## Executive Director's Recommendation

Commission Meeting: October 5, 2017

| <b>PROJECT</b><br><b>Central Parking Facility</b><br>National Zoological Park<br>3001 Connecticut Avenue, NW<br>Washington, DC | <b>NCPC FILE NUMBER</b><br>7911<br><br><b>NCPC MAP FILE NUMBER</b><br>2.00(38.00)44610                            |
| <b>SUBMITTED BY</b><br>Smithsonian Institution   | <b>APPLICANT'S REQUEST</b><br>Approval of comments on concept design  |

## **PARKING LOT C – MASSING MODEL**

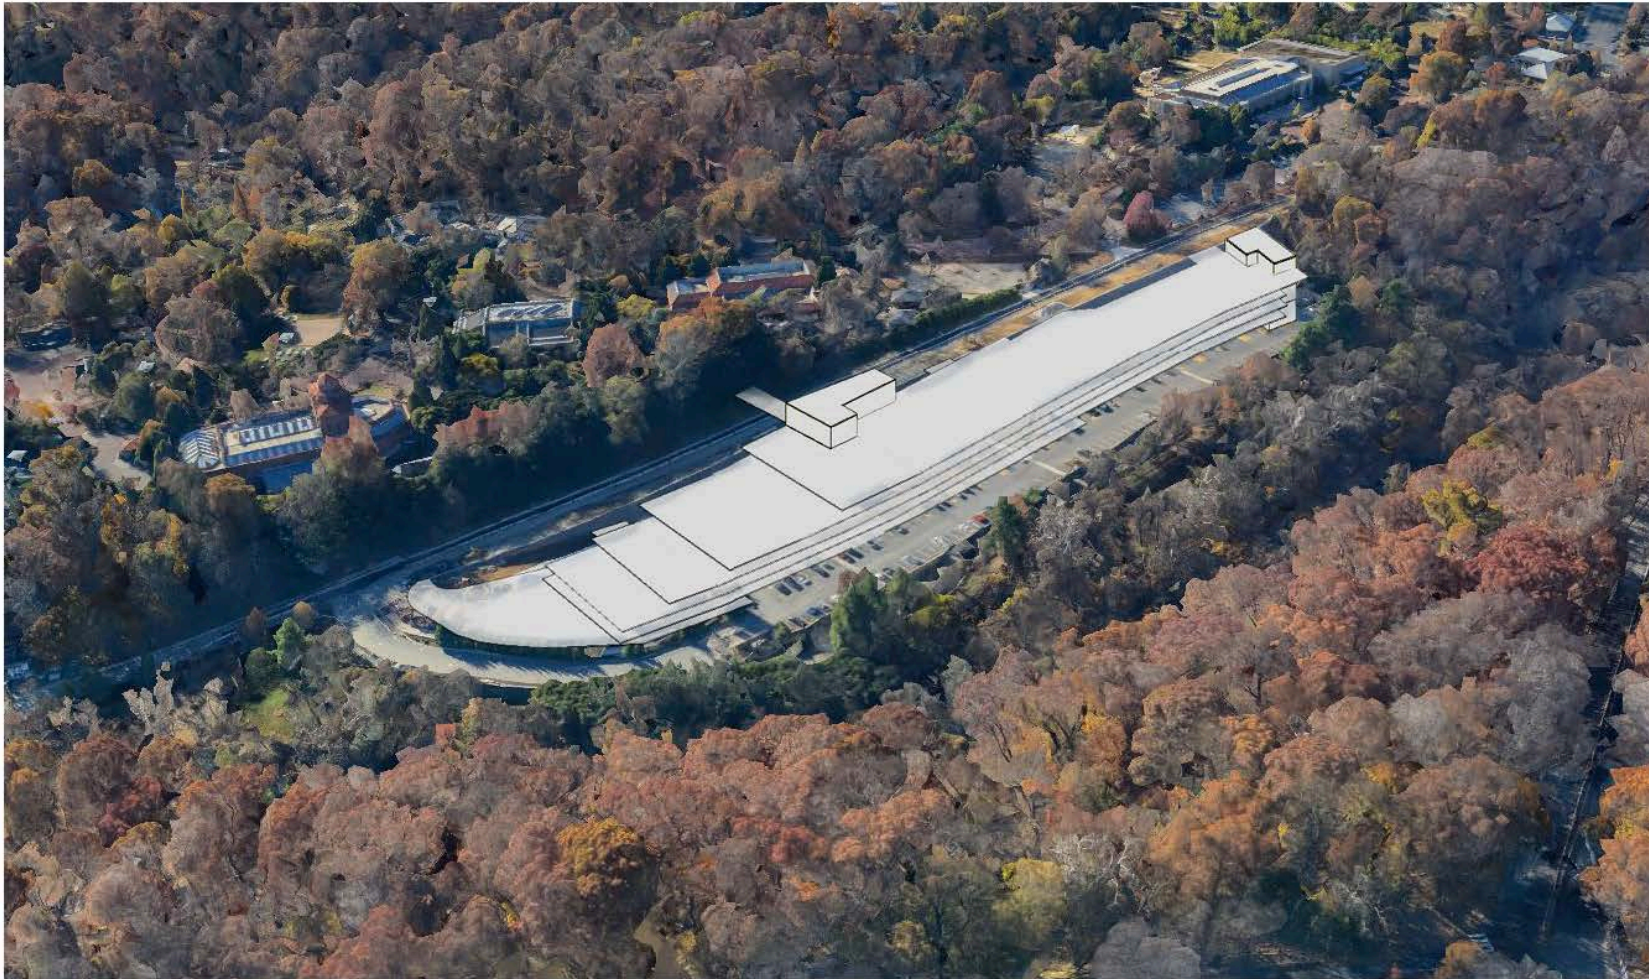
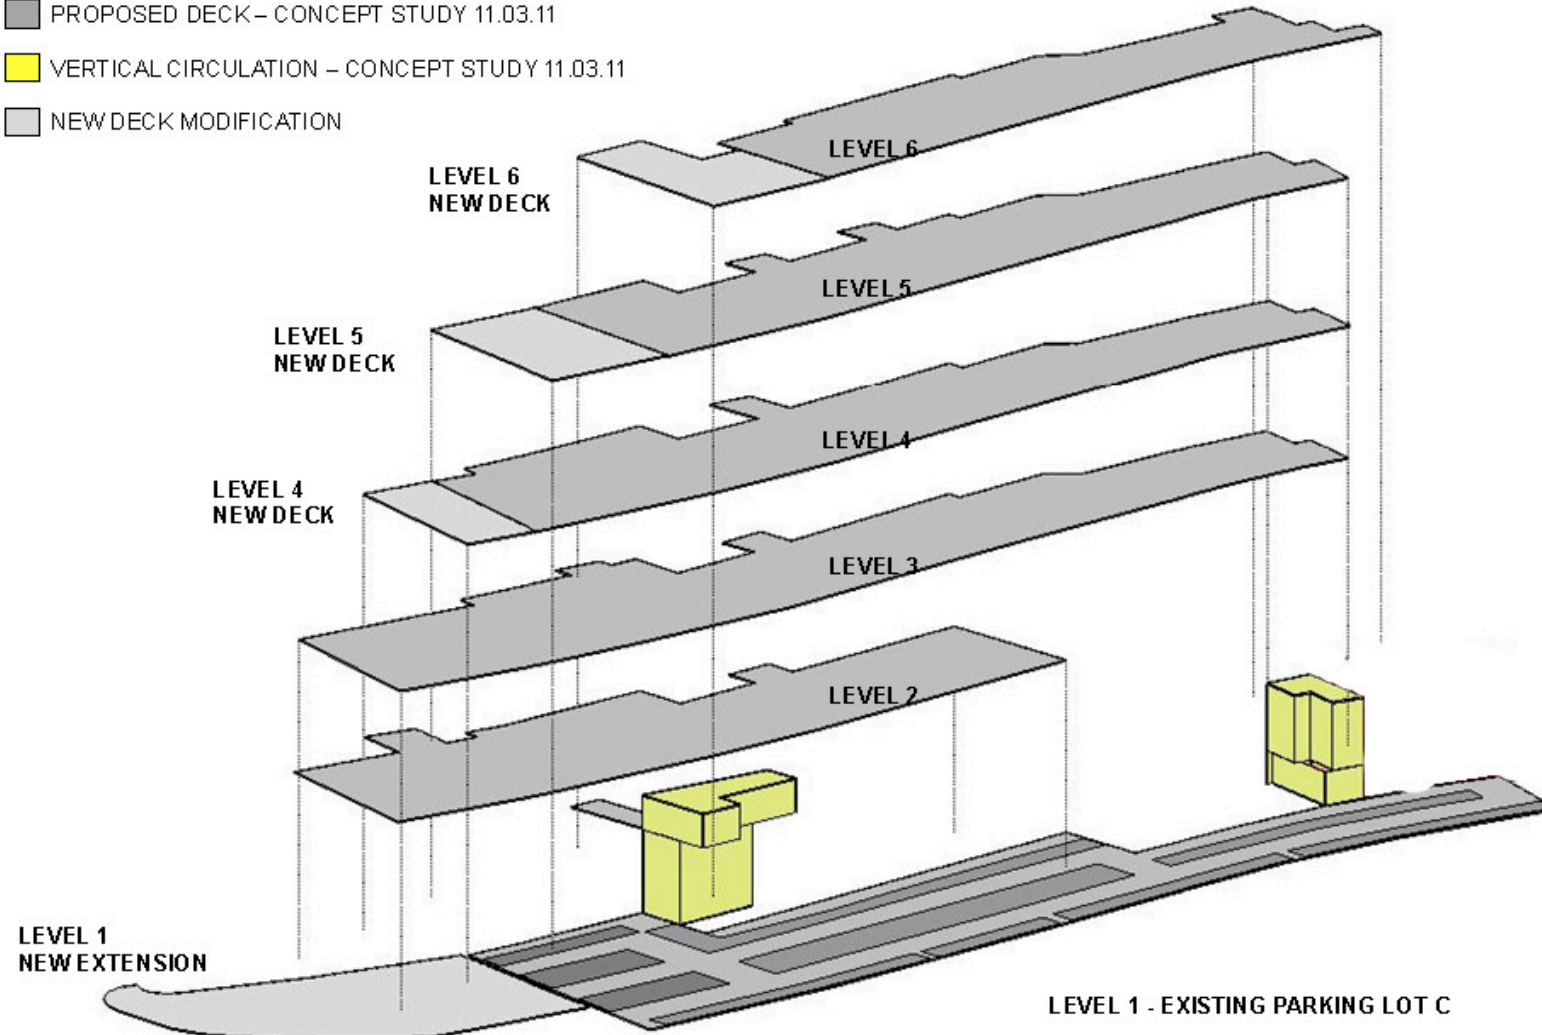
Viewshed analyses indicate that the massing of this larger garage could be effectively screened to minimize visual intrusion from the zoo's Olmsted Walk, and from Klinge and Adams Mill Roads. NCPC staff believes that additional views from Beach Drive and recreational trails in Rock Creek Park are also important to determine visual impacts. Because of the adjacent natural habitat, staff further believes that the CPF should be developed to effectively reduce stormwater runoff and emphasize sustainability. Accordingly, staff recommends that the Commission **requests that, in the continued development of the CPF, the SI:**

- **Pursues a design and massing that would minimize visual intrusion from Olmsted Walk and Rock Creek Park, with particular emphasis on views from Beach Drive and adjacent recreational trails;**
- **Protects the adjacent natural habitat by retaining and treating stormwater on-site to eliminate runoff into Rock Creek; and**
- **Follows best management practices related to low-impact development and sustainability, such as incorporation of green roofs, vegetated walls, and solar infrastructure.**

To ensure that NCPC has adequate information to evaluate the next iteration of the CPF, staff recommends that the Commission **requests that, for the next submission, the SI submits:**

- **An updated viewshed analysis that includes views from Beach Drive and adjacent recreational trails; and**
- **Alternative garage treatments that would reduce visual impacts.**
